CONSERVATION COMMISSION AGENDA

The Conservation Commission will hold this meeting as a virtual meeting on Thursday, June 4, 2020 at 7:00 pm. No in-person meeting will take place at City Hall.

24 Village Road – NOI – construction of new detached garage and new driveway – DEP File #239-866

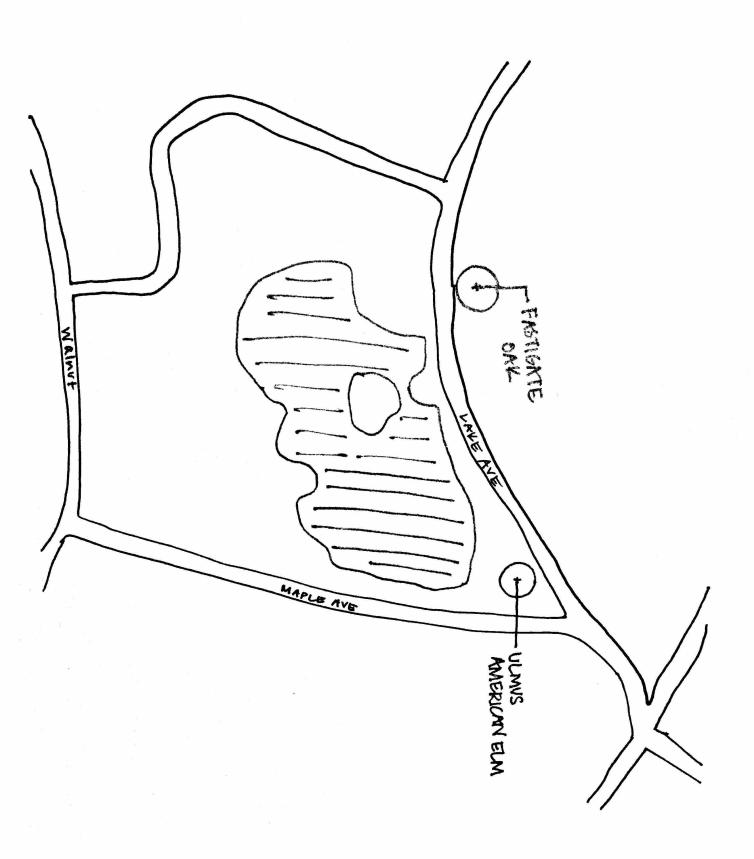
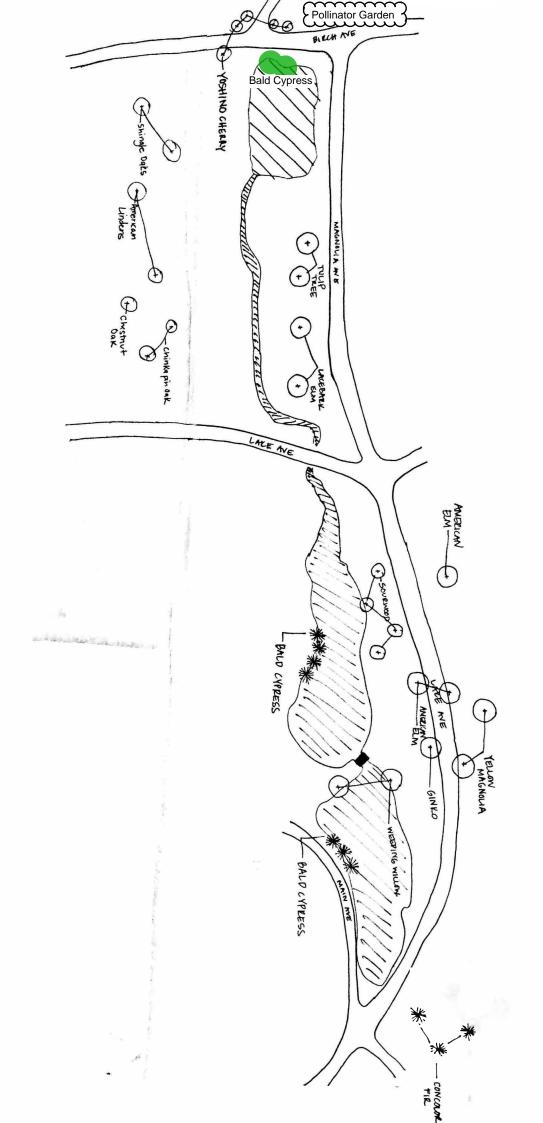
- The hand-sketch plans lack wetland resource area lines.
- The "treeid" table lacks a title and a date.
- Plan of tree removal does not clarify what removal has already been cut vs. what is proposed to be cut.

- Plan of tree removal does not show shrubs that have been cut recently
- The tree cutting and planting information provides no analysis of the proposed tree cutting and planting:
